King's Daughters

KD-3123.0-26

GC Services for UK King's Daughters Medical Center – Greenup Co. Urgent Care/Family Care Medical Office Building

ADDENDUM # 02

F-101
COPYRIGHT 2026 - JRA, INC.

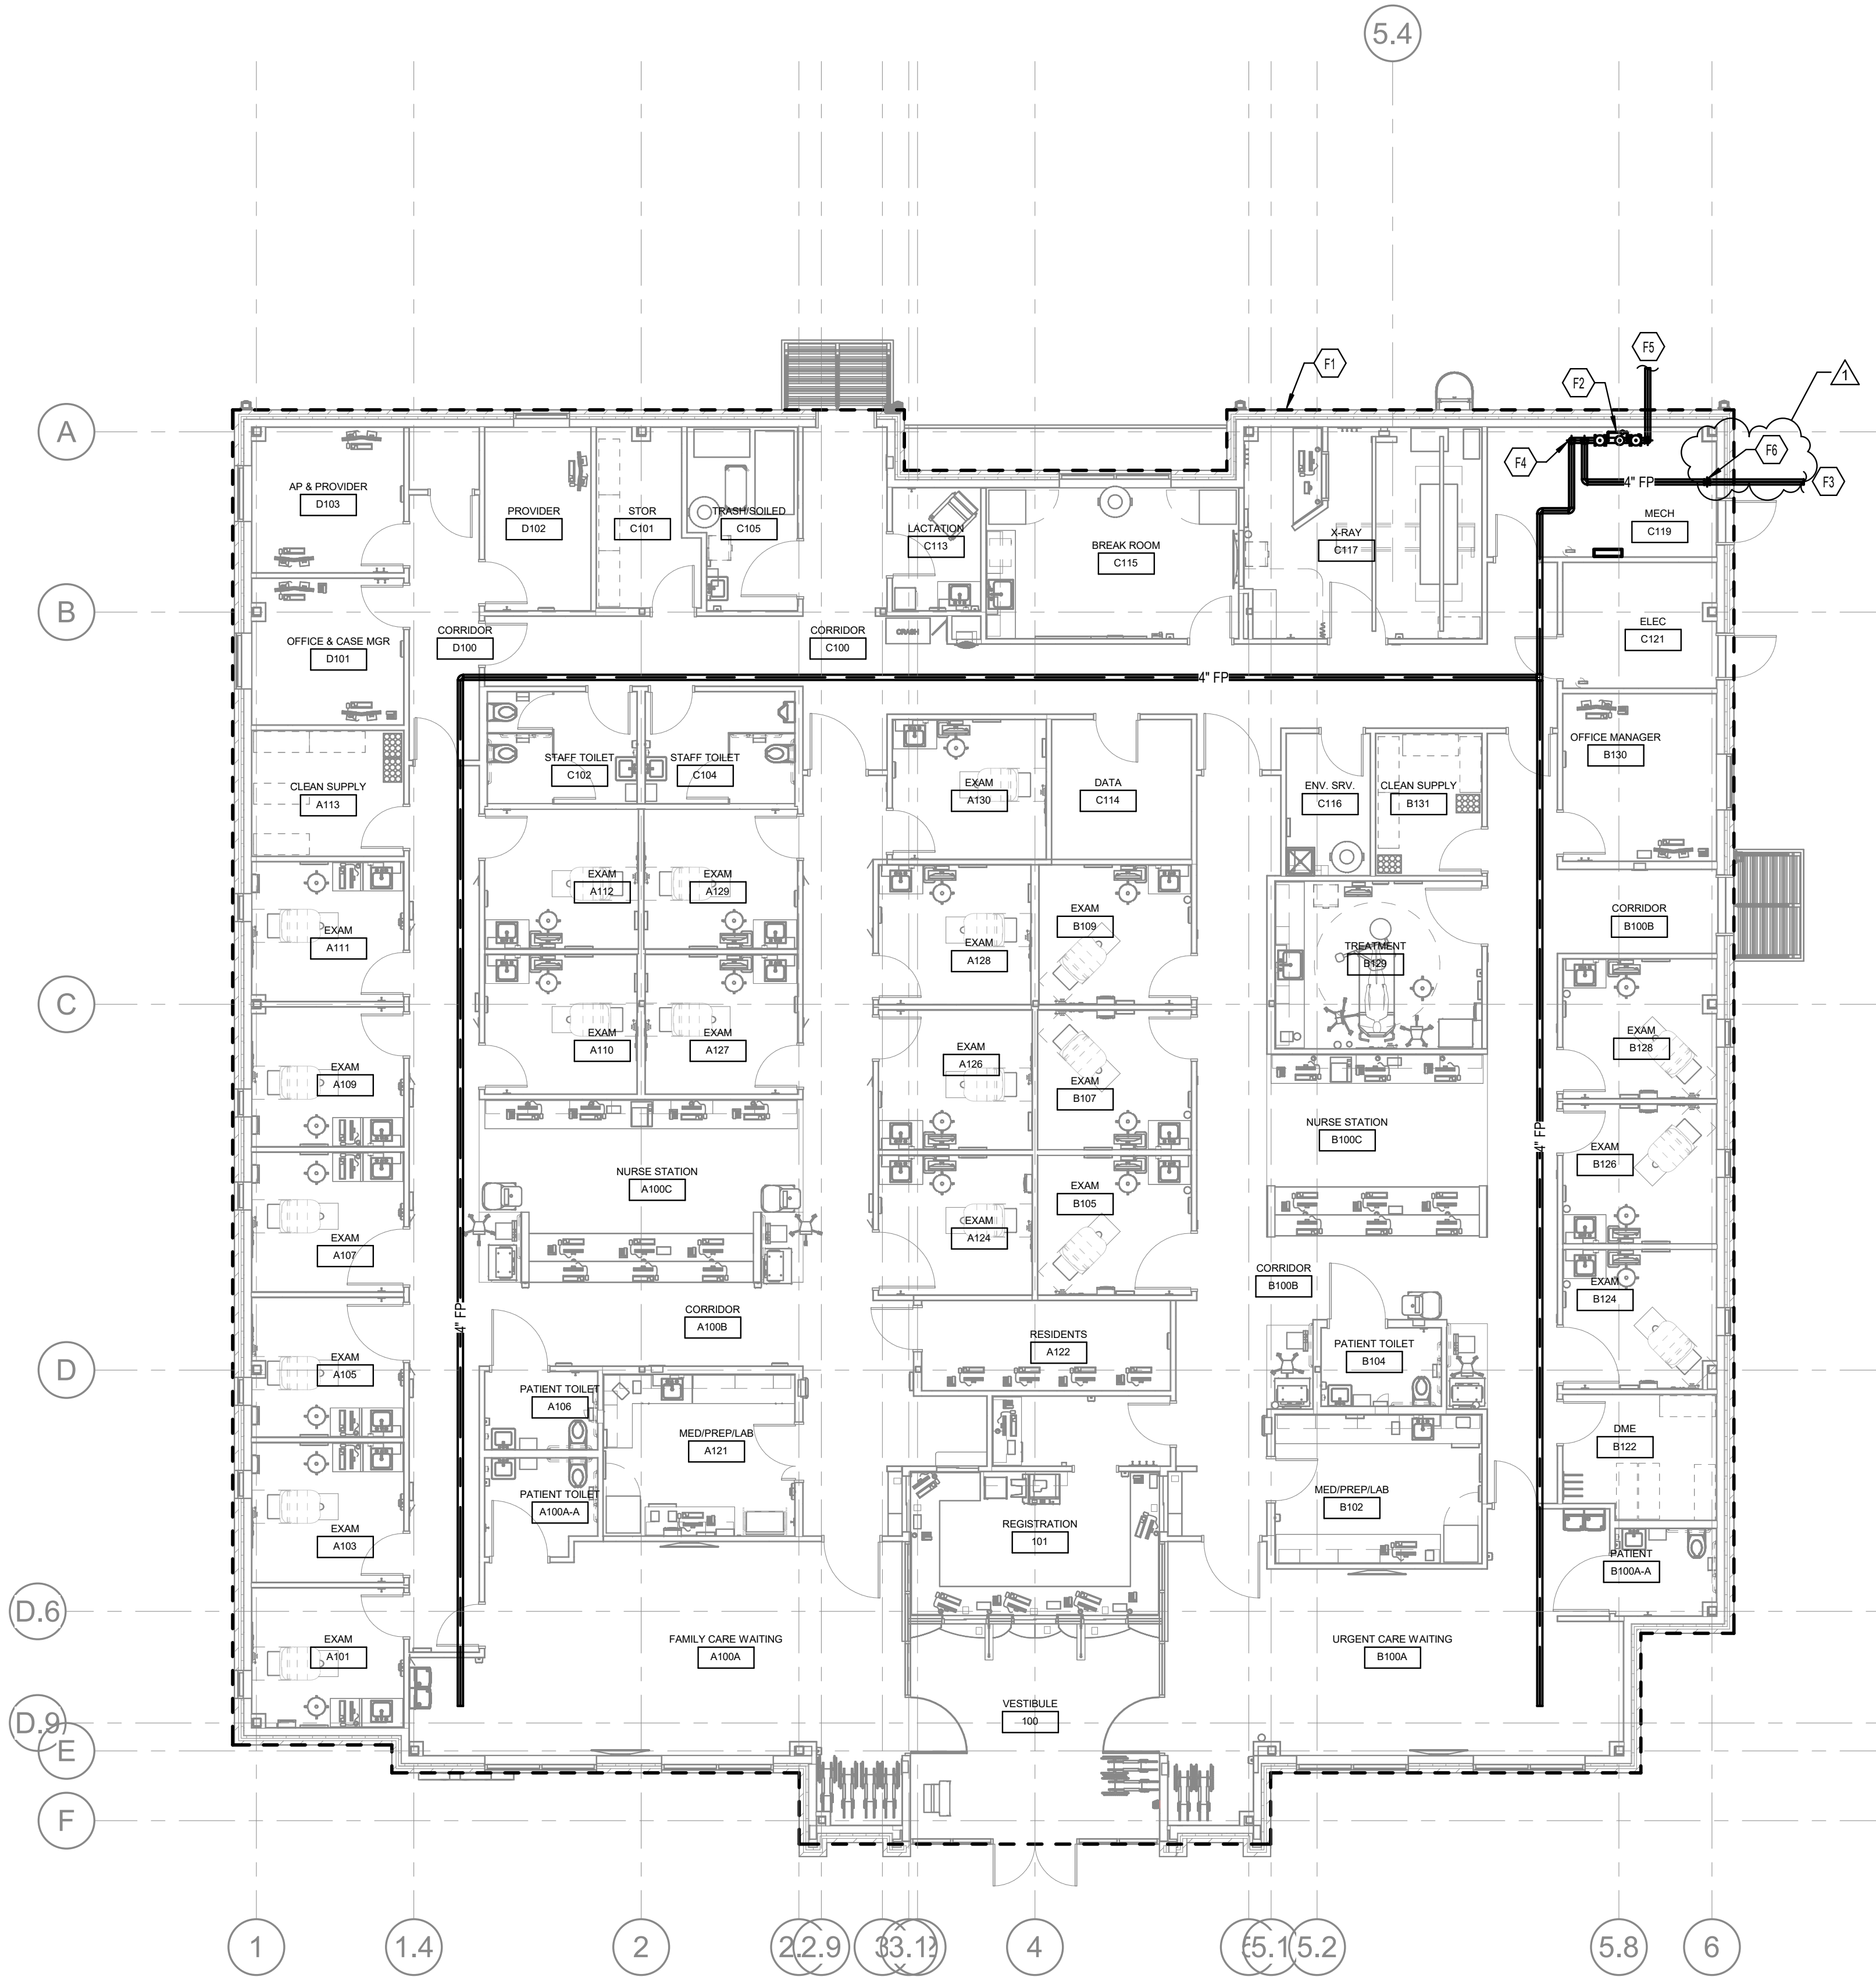
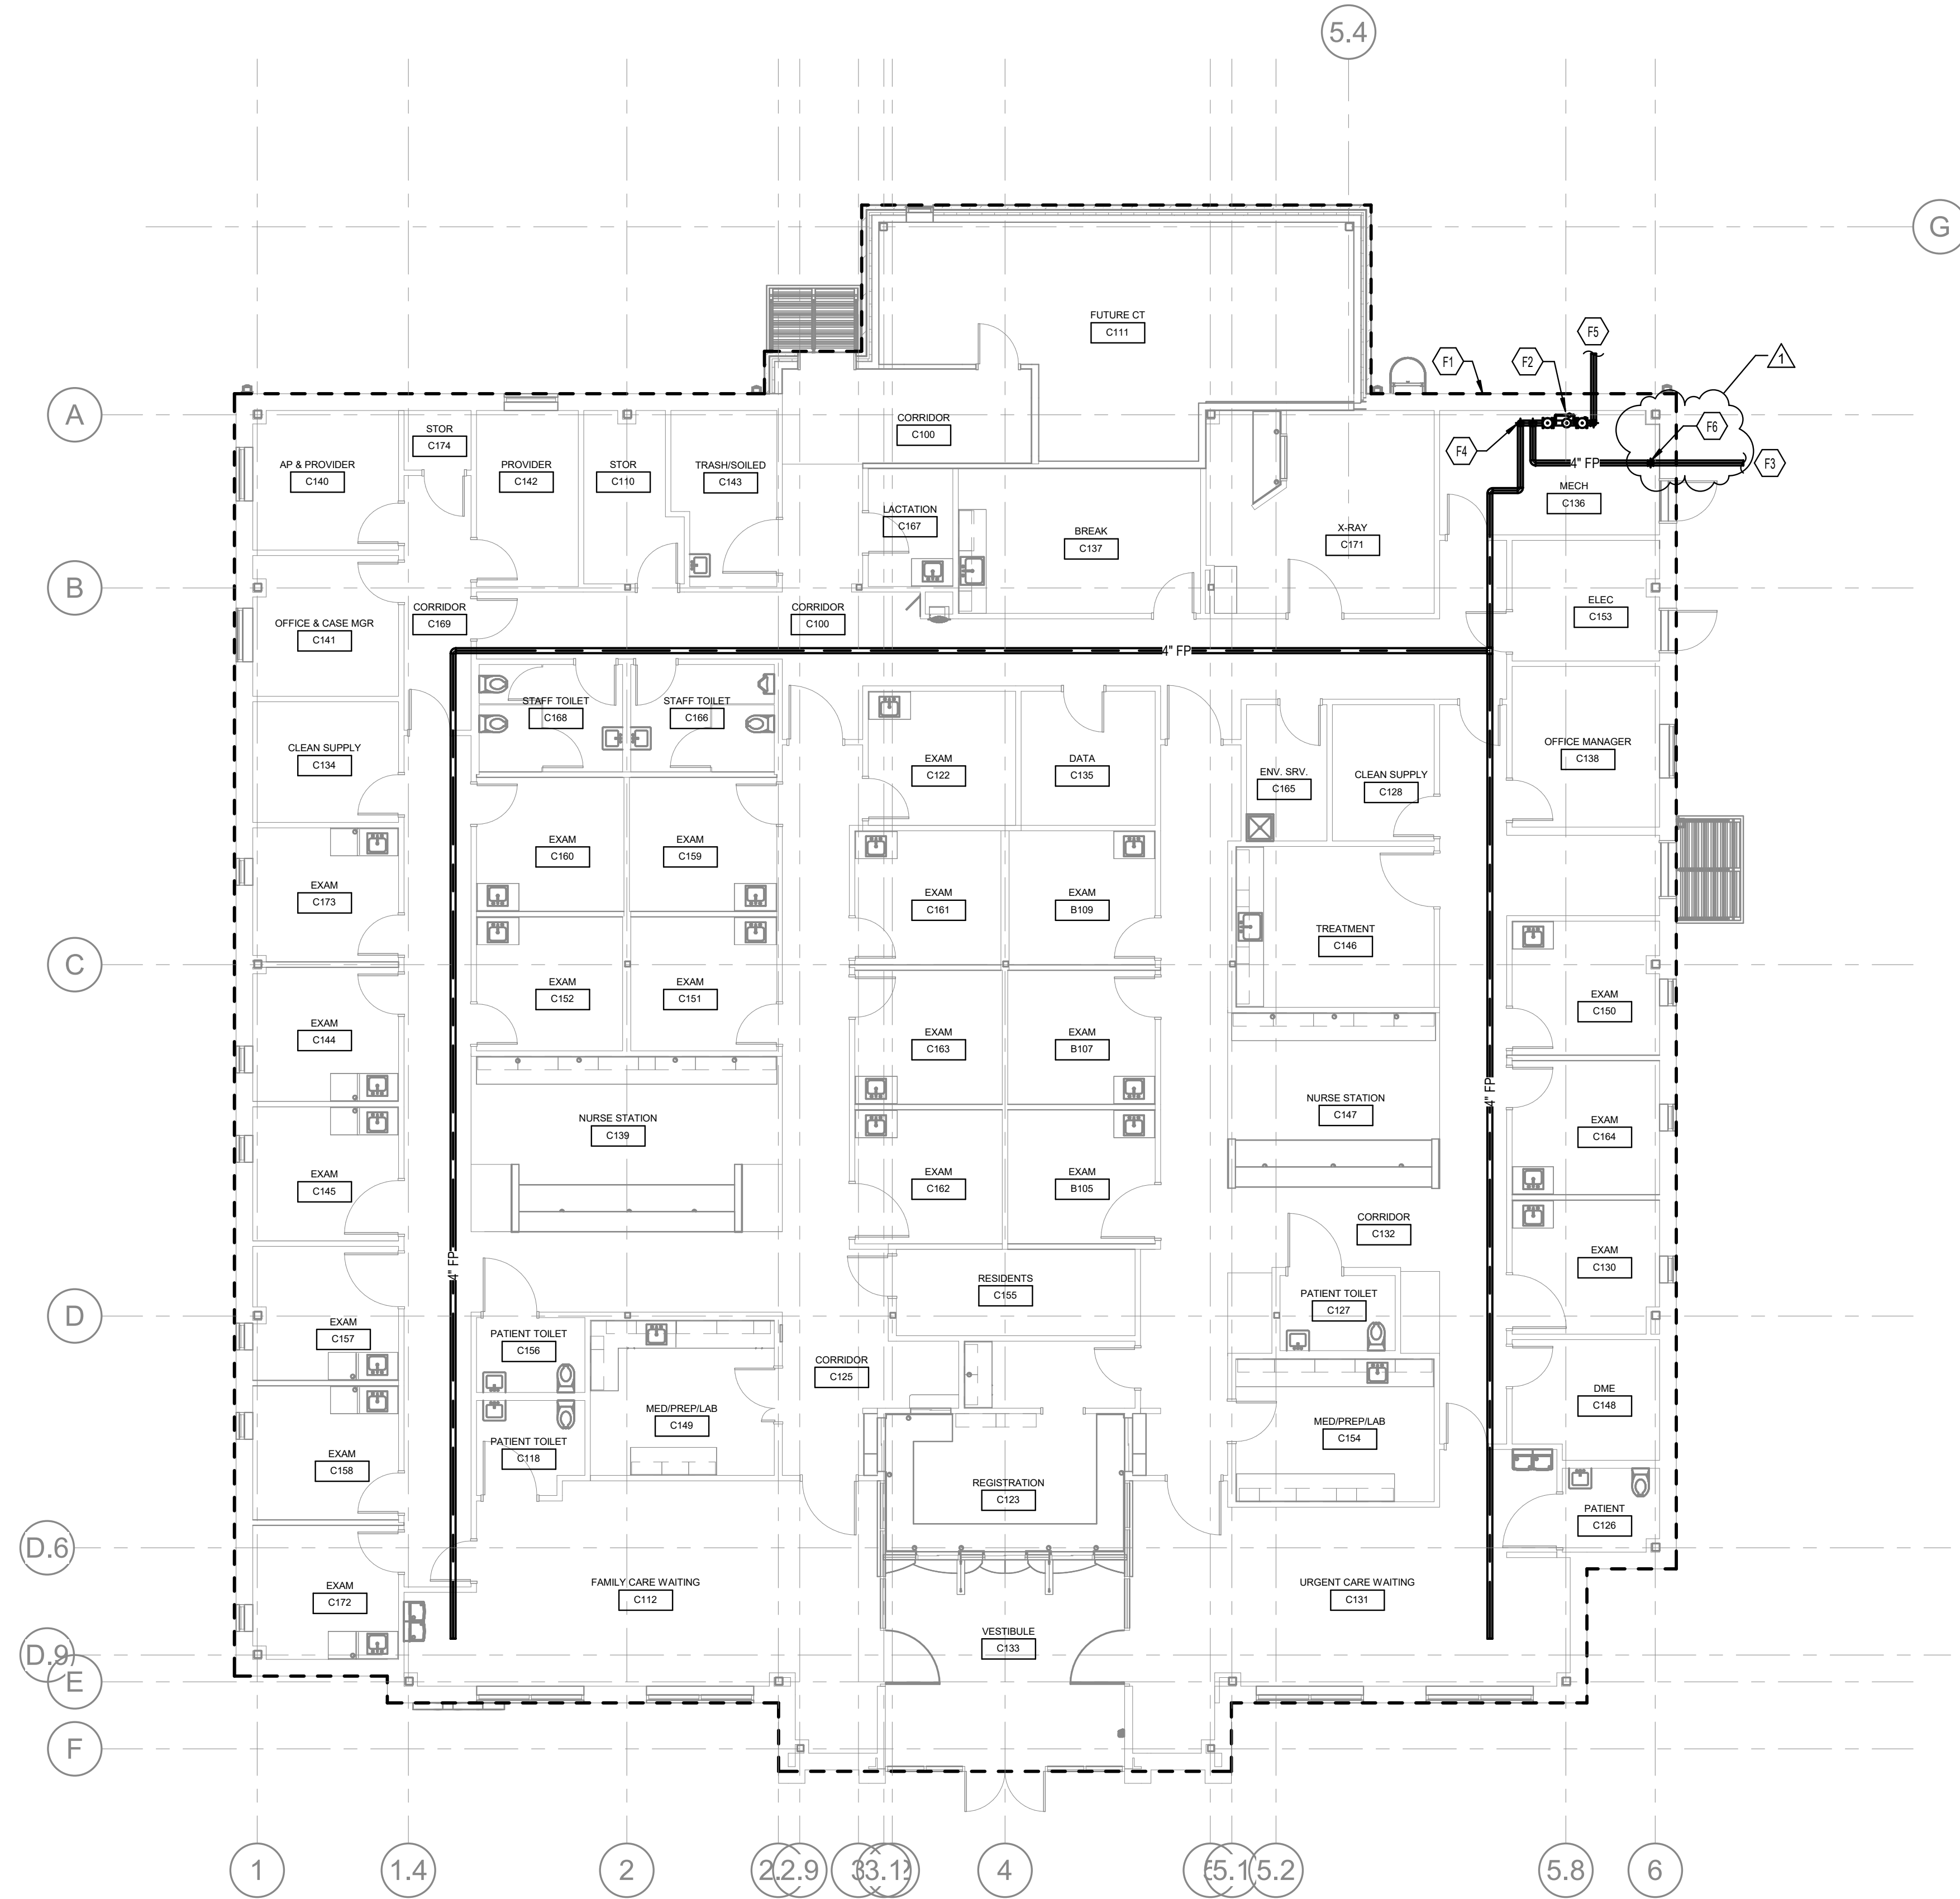
Refer to the attached revised Sheet F-101 Fire Protection Plan.

- Added Keynote F6 for check valve on the fire line for the Fire Department Connection located on site.
